City of Fitchburg Planning/Zoning Department 5520 Lacy Road Fitchburg, WI 53711 (608-270-4200)	**ARCHITECTURAL & DESIGN REVIEW APPLICATION**

On behalf of Kwik Trip, Inc., JSD Professional Services, Inc. (JSD) is requesting Architectural & Design Review (ADR) approval for the new development of a 9,200 SF Kwik Trip convenience store, fuel canopy and car wash to be located at the southeast corner of E. Cheryl Parkway and S. Syene Road in the City of Fitchburg. **The ADR was approved by Planning Commission on December 15, 2020, but the project will not break ground before the December 15, 2021 ADR expiration, therefore a resubmittal is needed.** The following is submitted together with plans and applications for review and approval by City of Fitchburg.

SOUTH SYENE ROAD
FITCHBURG, WI

DRAWN BY
SCALE
JSD PROJ. NO. 20-9726
DATE 12/07/2020
SHEET SP5

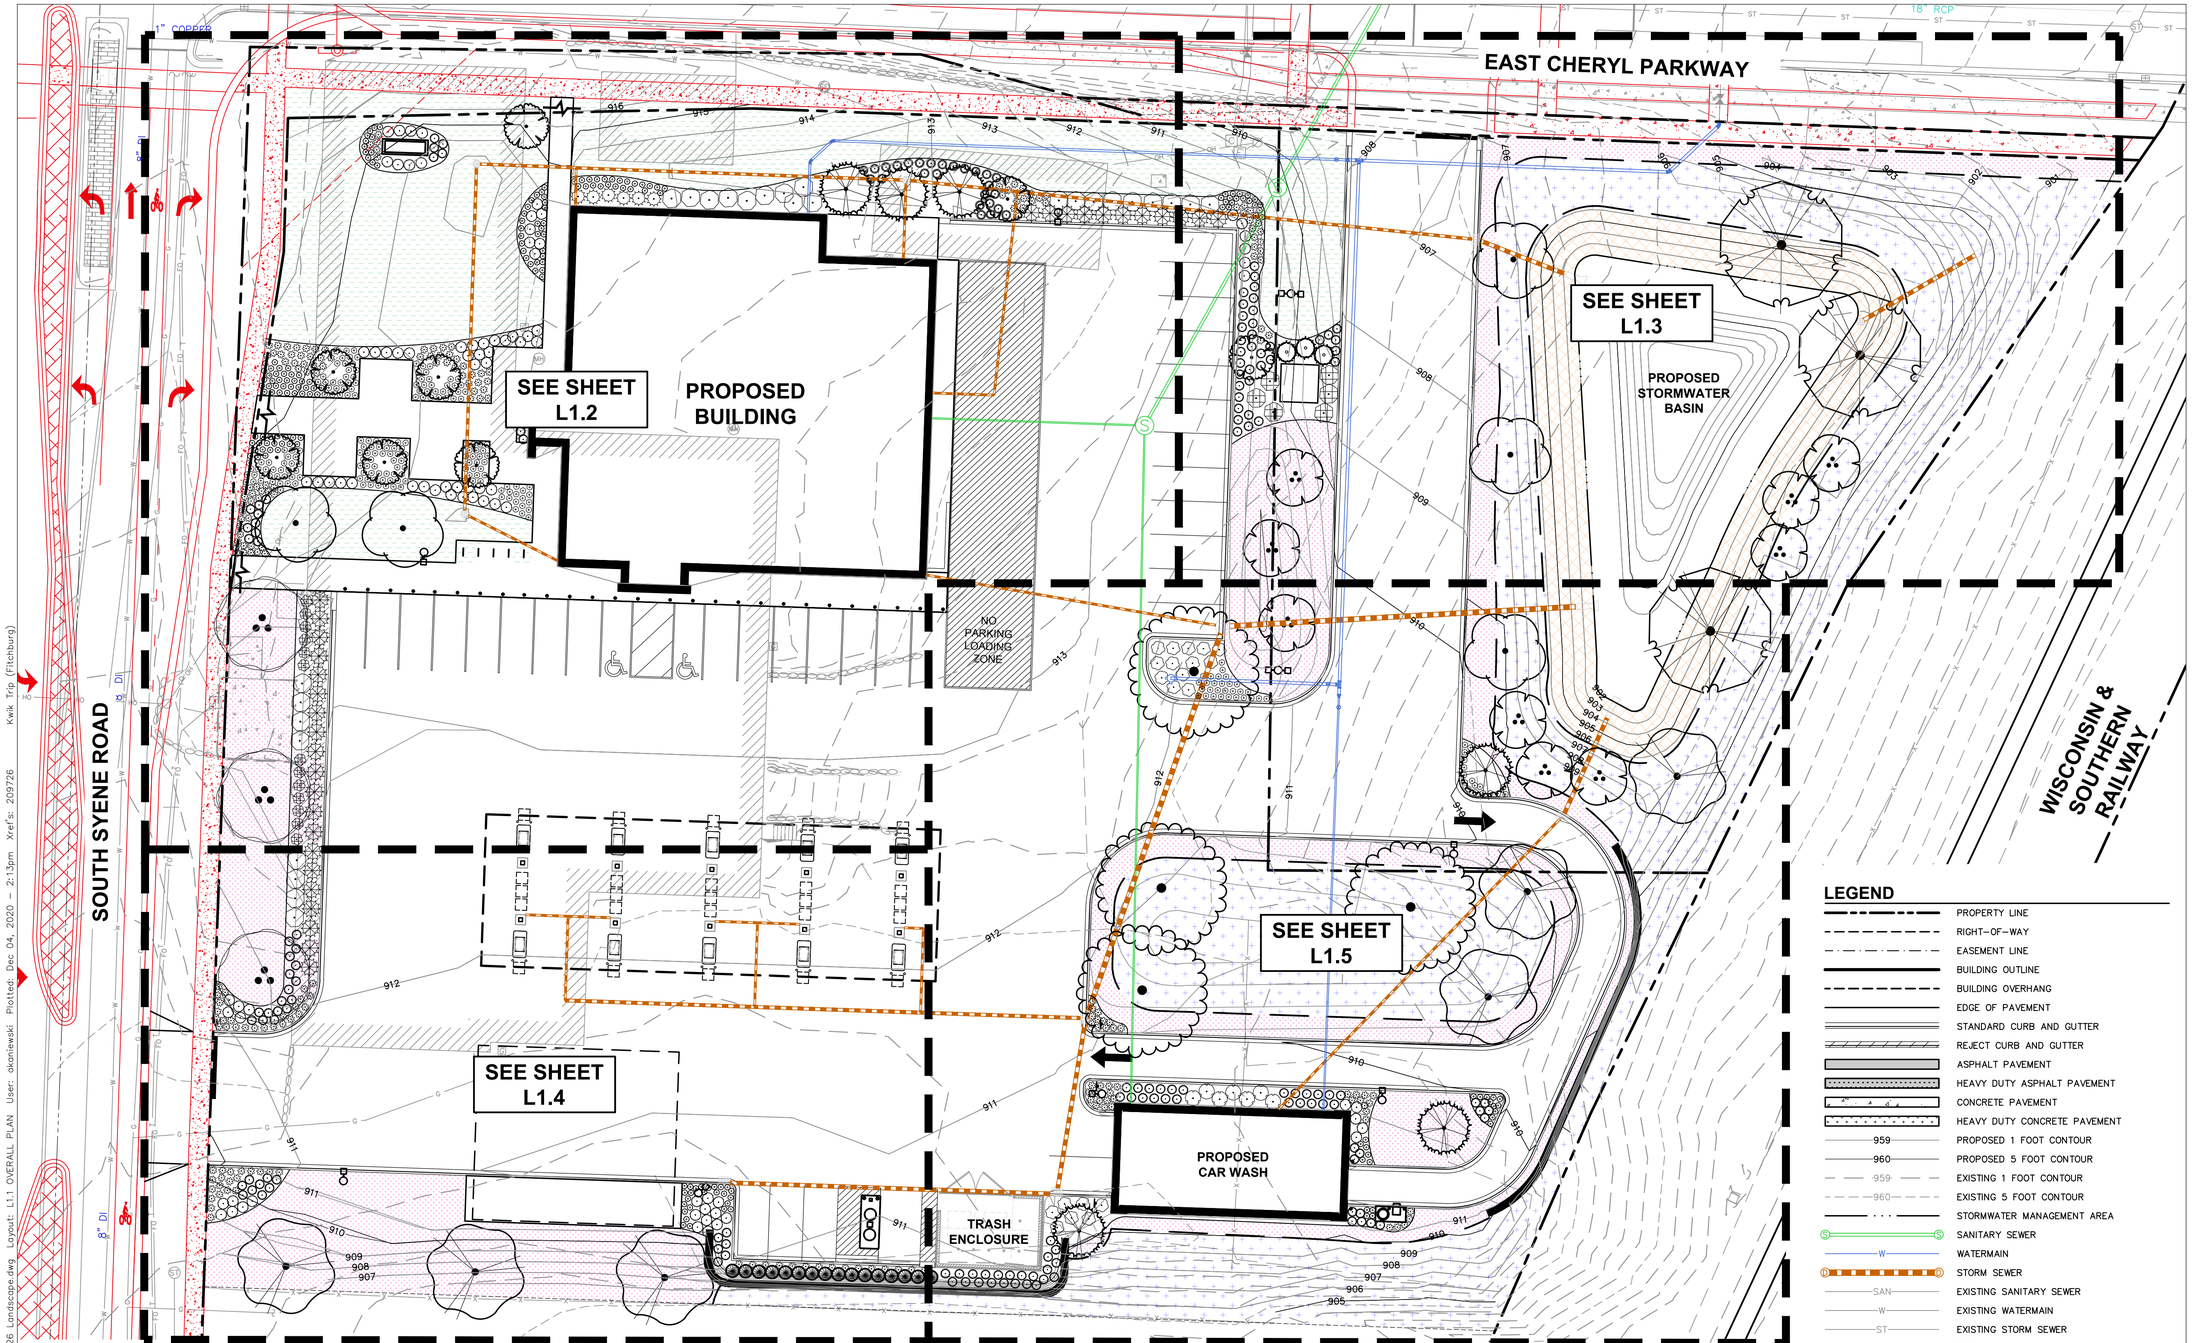
1. Comply with Fitchburg Ordinance Sec. 44-371 – Access road for construction sites
   Kwik Trip Response: Access Road for Construction Site notes have been added to Sheet SP5.
2. Comply with Fitchburg Ordinance Chapter 44, Article IV, Division 2. – Access for Apparatus
   a. A Fire Apparatus access plan shall be submitted for review.
      Kwik Trip Response: A Fire Apparatus access plan has been provided with this response to comments.
   b. A copy of the Fire Department's Ladder Truck dimensions for Auto-turn planning can be obtained from Deputy Chief Grossen.
      Kwik Trip Response: JSD Professional Services has requested and received the Ladder Truck dimensions from the Fire Department. The access plan is reflective of the Ladder Truck dimensions.
